General Aviation Division
Rockwell International

SERVICE INFORMATION NO. SI-102

EFFECTIVITY: MODEL 112, SERIAL NO'S 3 THRU 226.

SUBJECT: FAA AIRWORTHINESS DIRECTIVE 74-24-13.

Figure 1.

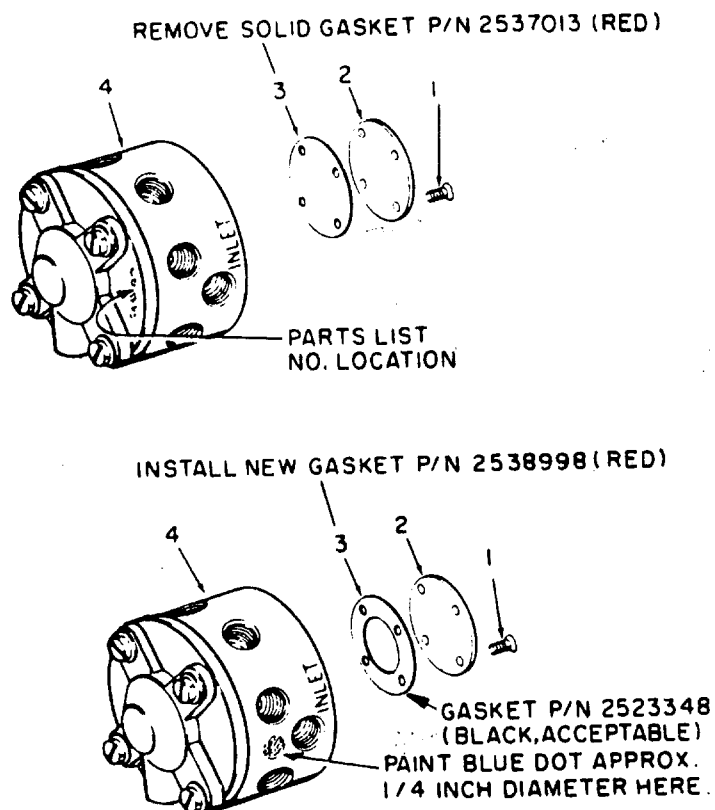
The purpose of this Service Bulletin is to inform operators of Bendix Fuel Injection Systems that there may be a possibility of the Cover Gasket P/N 2537013 (refer to Figure 1, Item No. 3) interfering with flow divider operation. To preclude this possibility the following instructions should be complied with.

B. REASON: To provide a new gasket between the flow divider body and cover P/N 2523747 (figure 1, item 2).

- (1) Gain access to the flow divider assembly.
- (2) Visually check Flow Divider Parts List Number to determine whether the provisions of this bulletin apply.
- (3) If applicable, remove all lines from the flow divider assembly. Cap and plug all open lines and fittings with suitable protective coverings. Remove flow divider from engine.
- (4) With the flow divider on a suitable work bench, remove the four Countersunk Screws P/N 902646K1, Cover Assembly P/N 2523747 and Gasket P/N 2537013. (Refer to Figure 1, index 1, 2, 3, and 4.)

- (5) During reassembly (refer to figure 1), install new Gasket P/N 2538998, Cover P/N 2523747 and new Screws P/N 902646K1 if required. Prior to installation, apply Loctite, Grade A or C, to the first two threads of screws. Tighten screws to 8-11 pound-inches torque.
- (6) Reidentify flow divider as follows:
 - (a) Scribe a dash 2 (-2) after P/L number.

- (1) Prior to return to service replace solid Gasket P/N 2537013 with new Gasket P/N 2538998.
- (2) Reference: Bendix Overhaul Manual, Form 15-540A, dated 15 July 1974.
- (3) Reidentify flow divider as follows:
- (a) Scribe a dash 2 (-2) after P/L number.
- (b) Paint a blue dot next to flow divider inlet approximately 1/4 inch in diameter.

Figure 1. Interior View of Accessory Housing Showing Location of Cotter Pin in Oil Pump Idler Shaft

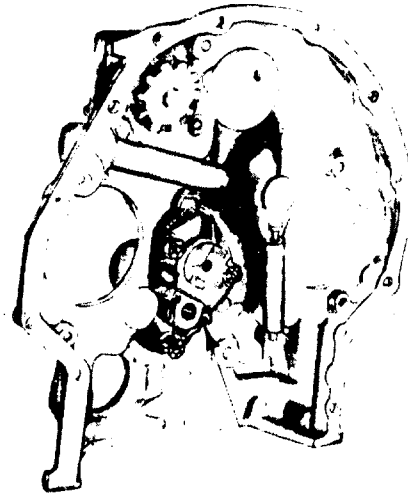
INSPECTION: Applicable remanufactured engines shipped after December 21, 1972 should be inspected to determine if this modification is required: first of all, if the engine log book indicates the engine has not been modified in accordance with Service Instruction No. 1230 or No. 1272, proceed to remove the accessory drive cover from the mounting pad at the lower right side of the accessory housing to obtain access to the area between the crankcase and the accessory housing. On some engines this accessory drive pad is not machined, in this event it will be necessary to remove either the left magneto or the *fuel pump to obtain access to the area between the crankcase and the accessory housing. Regardless of which accessory pad is used, determine if the oil pump idler gear is secured with a cotter pin at the location shown in figure 1. This can be accomplished using an inspection mirror, preferably an illuminated one. If the cotter pin is visible, it is unnecessary to perform the modification required by this bulletin.

IF IDLER SHAFT IS SECURED
WITH A COTTER PIN AT THIS LOCA-
TION MODIFICATION IS NOT REQUIRED

Figure 2. Oil Pump Drive Assembly

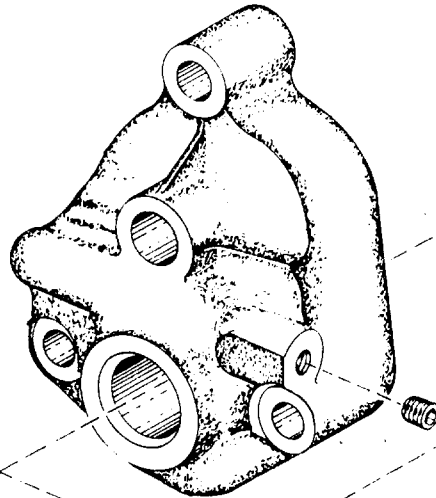
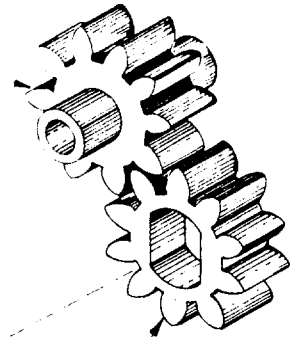
This modification consists of replacing the oil pump drive shaft and drive impeller to eliminate the Woodruff key drive which has proven to be the cause of excessive wear in the keyway of the hardened drive impeller. Therefore, it is recommended that all of the applicable engines listed above, as well as any others that may have been modified in accordance with Service Instruction No. 1272, use the following procedure for parts replacement.

3. Reassemble the oil pump using the new drive shaft and drive impeller supplied with the kits shown in the following "Parts Data" section. See figure 2. Be sure all of the parts are lubricated thoroughly during assembly. After assembly, turn the drive

Figure 1. Identification of Switch Parts.

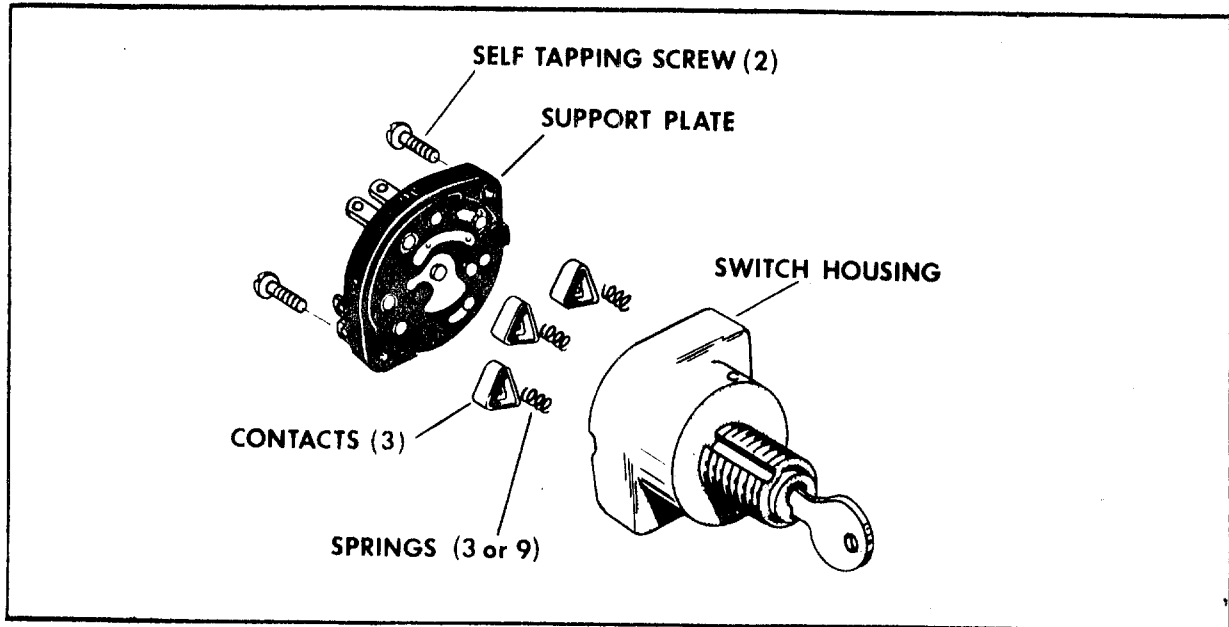
B. To install a new Support Plate and Contacts, proceed as follows using Figure 1 as a guide for parts identification.

1. Disassembly and Inspection.
 - a. Hold switch in a vertical position, support plate up.
 - b. Using firm finger pressure, hold the support plate against the switch housing while removing the two self tapping screws. Retain screws for use during reassembly.

- c. Directly beneath the support plate are three contacts, spring loaded against the support plate. Carefully separate the support plate from the main switch assembly and remove the three contacts and springs (3 or 9).
- d. Retain the springs for use during reassembly. Discard old support plate and contacts.
- e. Inspect remainder of switch assembly for smoothness of operation

Figure 1.

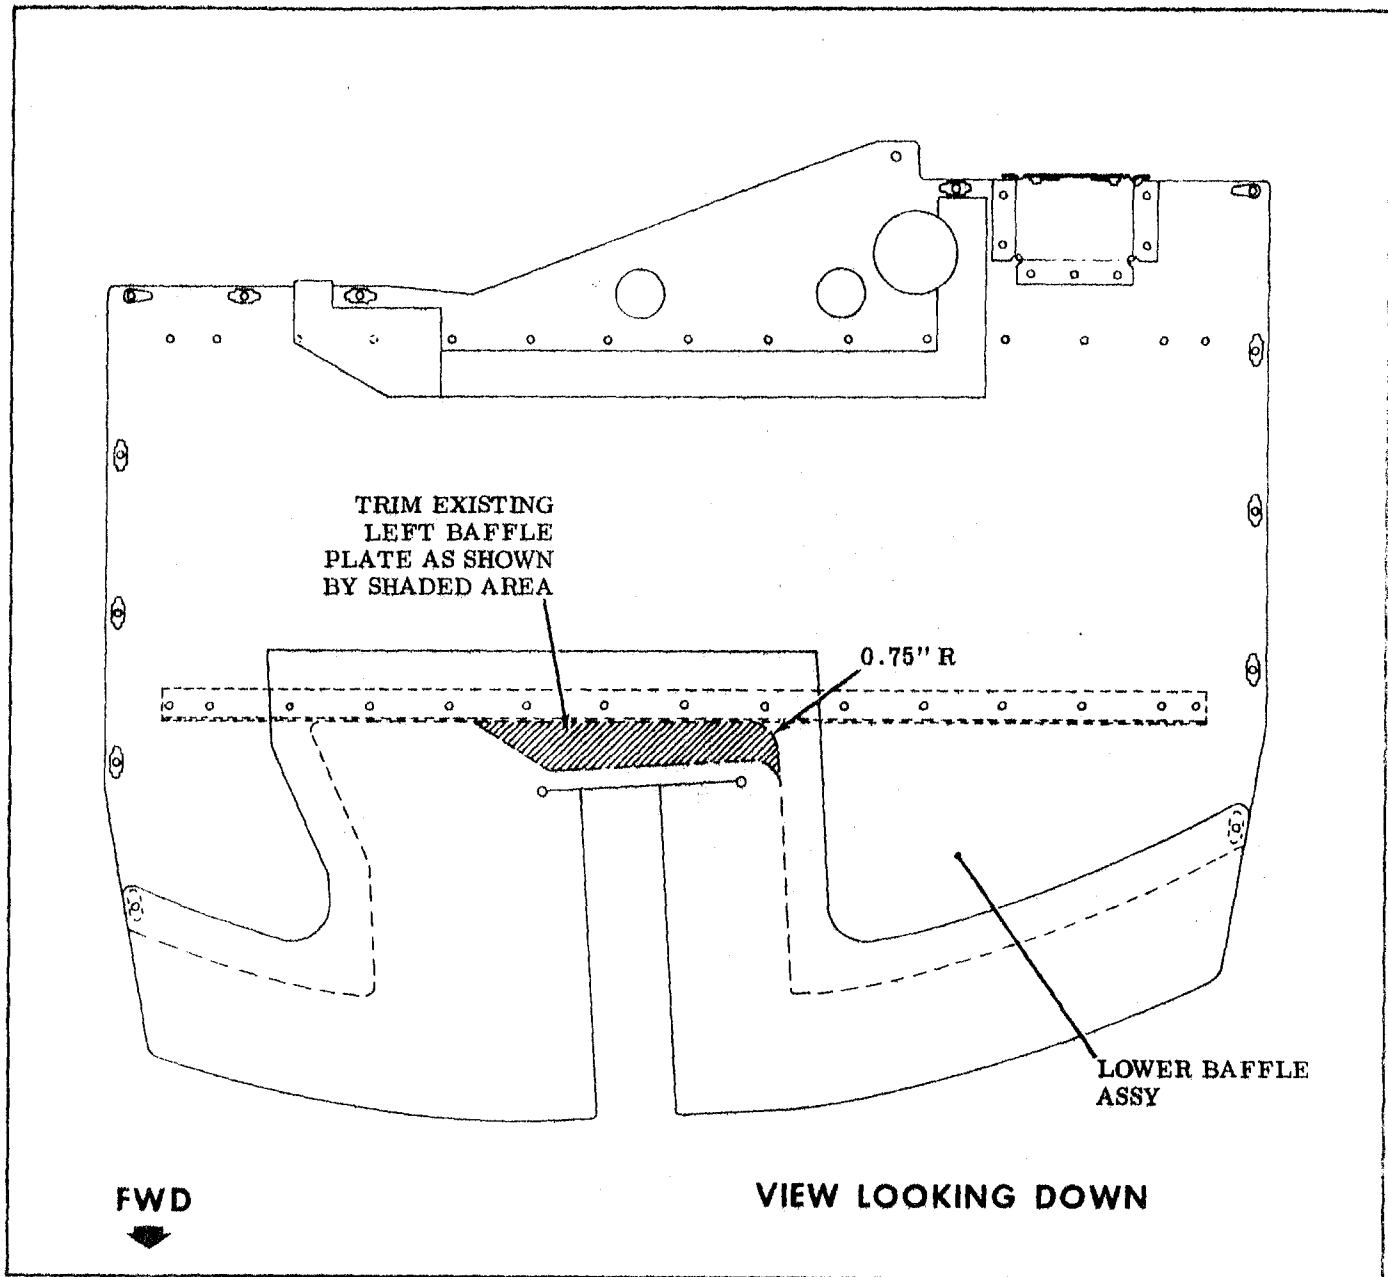
1. Remove upper and lower engine cowling as outlined in the Airplane Maintenance Manual, Section IV.
2. Remove staples through seal and baffle plate on lower baffle assembly in area to be trimmed (see Figure 1.).
3. Trim lower left baffle plate as shown in Figure 1.
4. Reinstall upper and lower engine cowling as outlined in the Airplane Maintenance Manual, Section IV.

Figure 1.

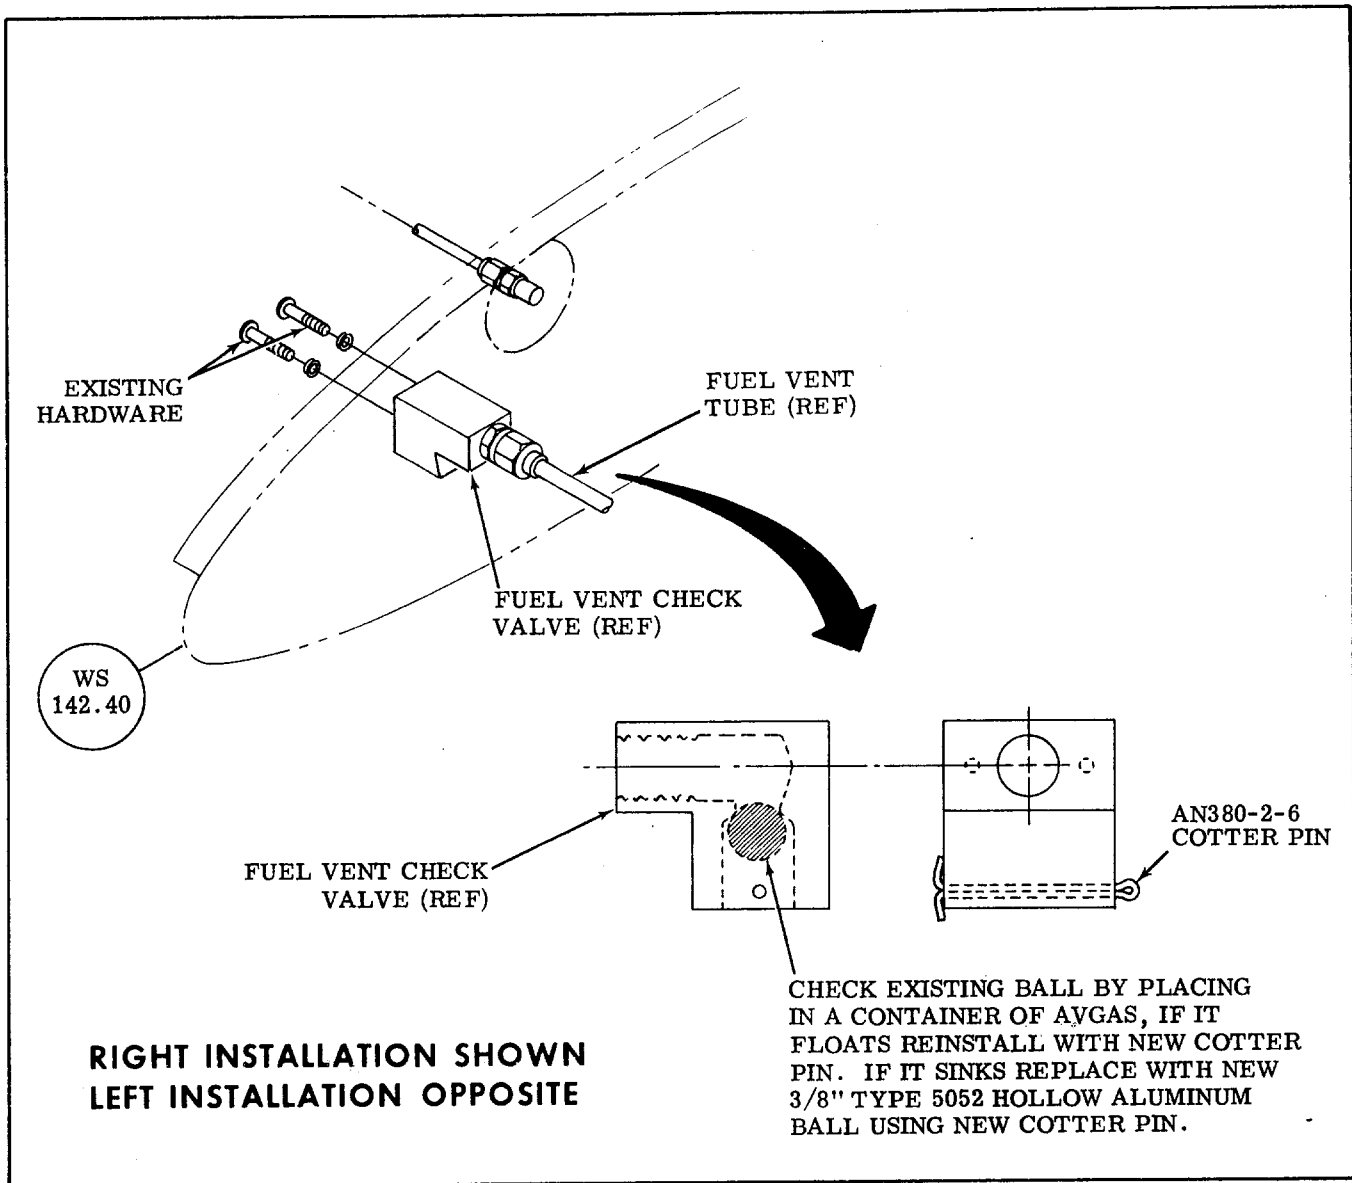
Fuel leakage may be observed at lower fuselage fuel vent outlet particularly when the tanks are full.

2. If no leaks are evident at lower fuselage fuel vent outlet, disregard this Service Information Letter.
3. Defuel airplane as outlined in the Airplane Maintenance Manual, Section II.
4. Remove outboard fuel cell access plate to gain access to fuel vent check valve.
5. Remove outboard wing access plate to facilitate removal of fuel vent check valve.
6. Disconnect left and right fuel vent tube assemblies from left and right fuel vent check valves.
7. Remove screws attaching fuel vent check valves to left and right wing ribs at W.S. 142.40 and remove check valves from airplane.
8. Remove cotter pin and ball from fuel vent check valves.
9. Place check valve balls in a small container of Avgas.
10. If check valve balls float, reinstall in existing fuel vent check valves using new AN380-2-6 cotter pins (see Figure 1.).

11. If check valve balls do not float, discard existing balls and install new 3/8-inch balls using new AN380-2-6 cotter pins (see Figure 1.).
12. Reinstall existing fuel vent check valves in airplane using existing hardware.
13. Reconnect left and right fuel vent tube assemblies to fuel vent check valves.
14. Thoroughly clean all surfaces, to which sealing compound is to be applied, around fuel vent check valve and valve attaching screws with Methyl Ethyl Ketone (MEK) using clean paper towels or small paint brush and wipe clean.

Figure 1.

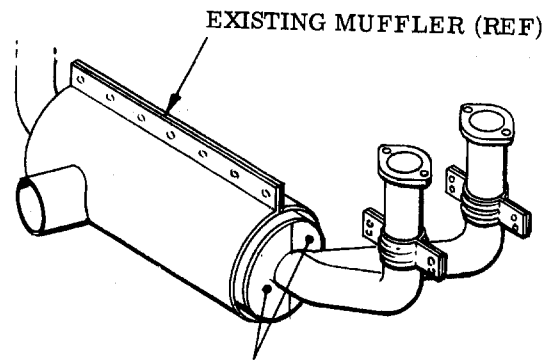
INSPECT THIS AREA AND IF NO CRACKS ARE FOUND
INSTALL TWO DOUBLERS AS SHOWN BY HELI ARC
WELDING AROUND INSIDE AND OUTSIDE DIAMETERS
OF DOUBLERS AND AT THE TWO PLACES WHERE
THEY JOIN.

MAKE TWO DOUBLERS FROM 20 GAUGE
(0.0375") 321 STAINLESS STEEL MIL-S-6721
AS SHOWN ABOVE

Figure 1.

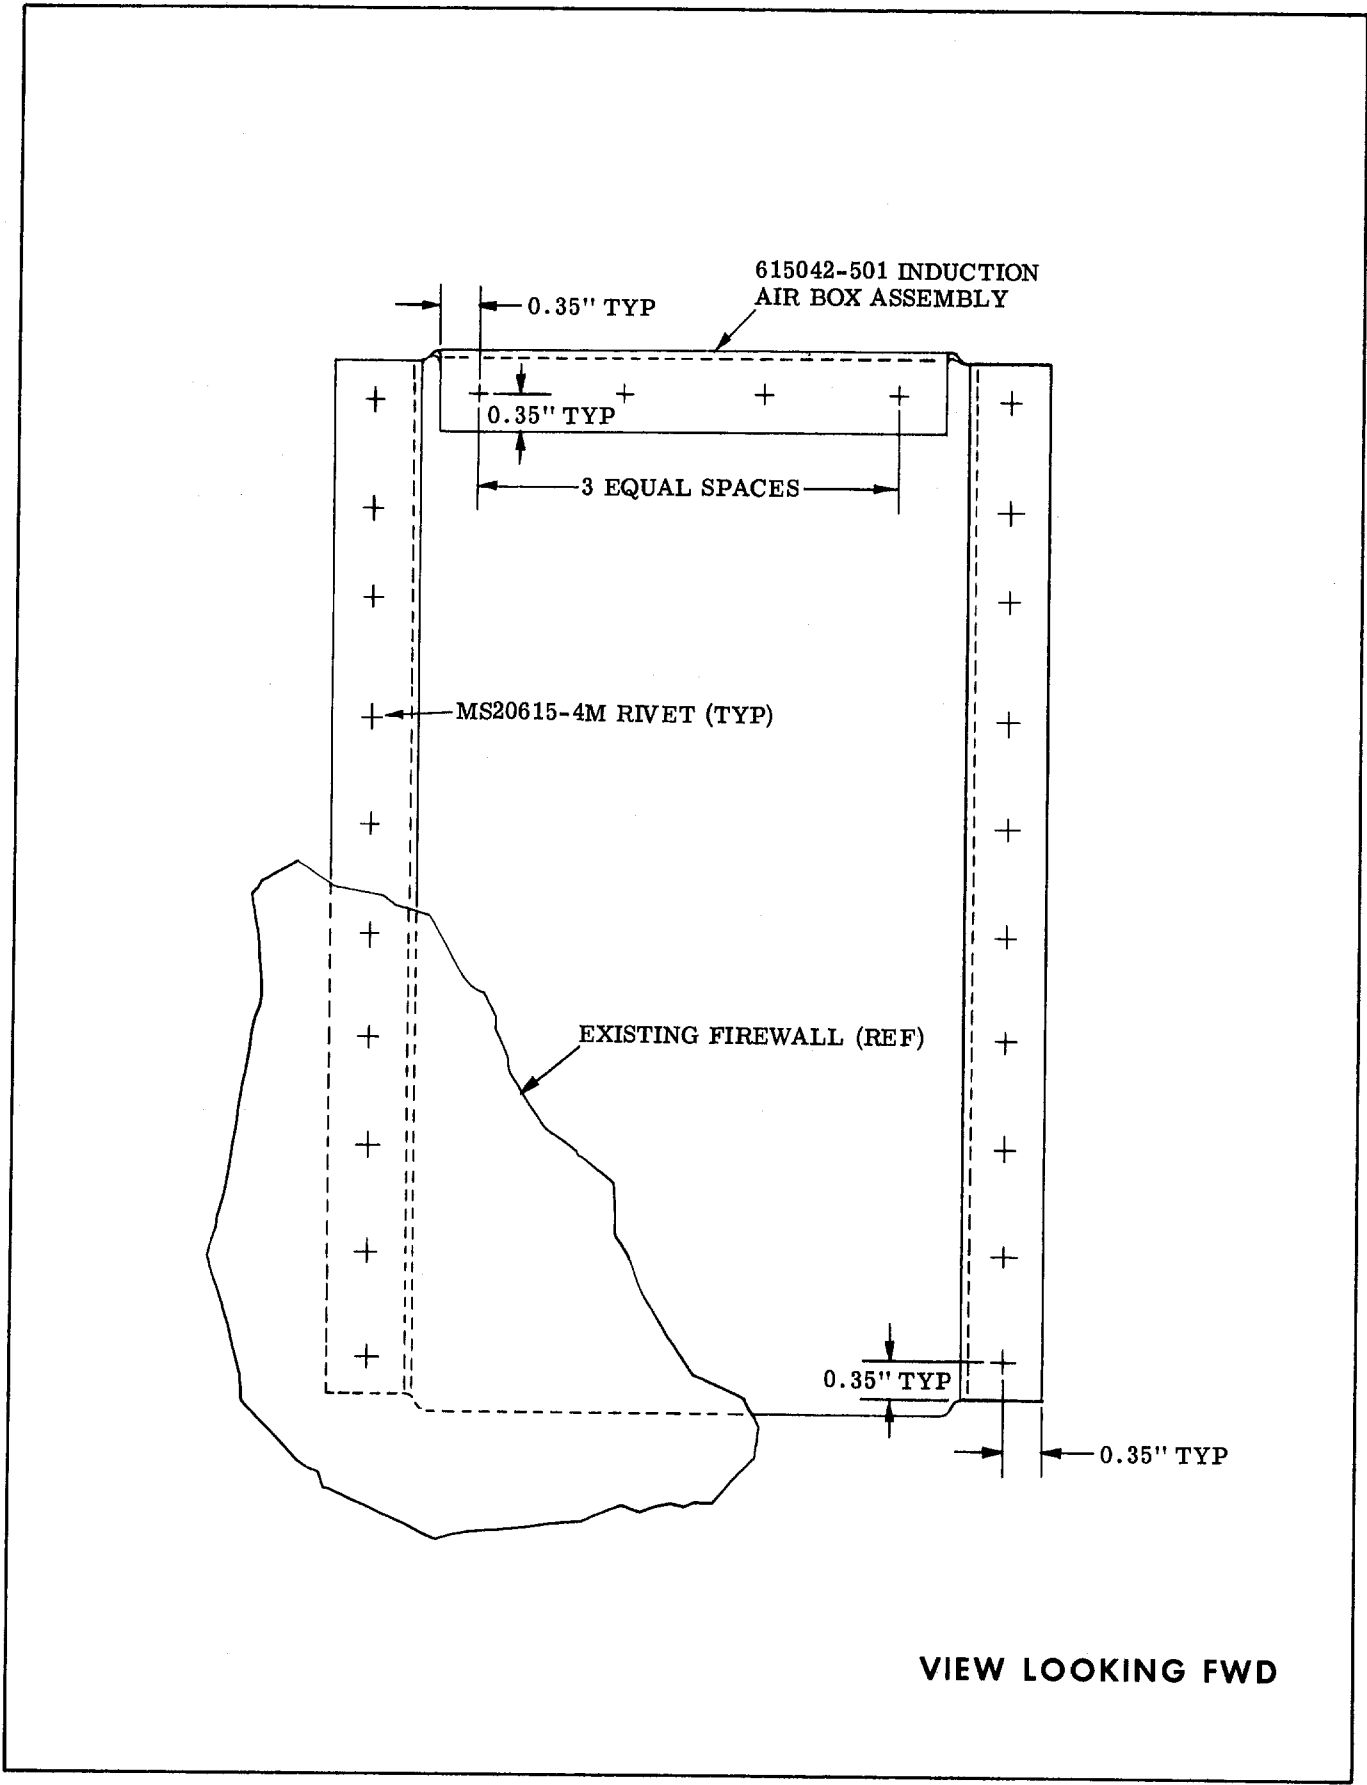
9. Locate, drill and install 615042-501 induction air box assembly on firewall using MS20615-4M rivets (see Figure 1.).
